Access Compliance Report

Public Rights-of-Way

Intersection ID: 12548	Main Street: E MARTIN LUTHER KING JR BV	Cross Street: S TRYON ST	Location: E
ADA ID: A665D5F7D94D	Ramp Type: PerpDiag	Initial Pass/Fail: Fail	Overall Compliance: No
Codes/Mitigation Info/Possible Solution		Field Measurements/Component Compliance	
Severity Score: 12.5

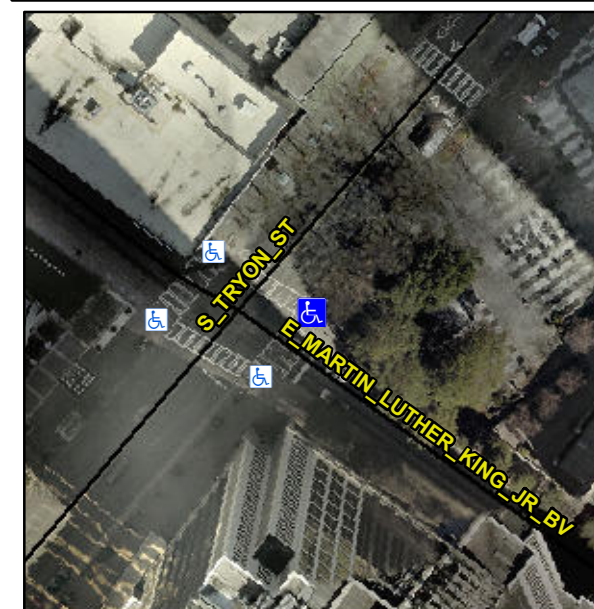
Surveyor Notes:

N/A

PROW/ADA:

R304.2.2

Possible Solutions:

Remove & Replace Curb Ramp With Two New Directional Ramps or Equivalent.
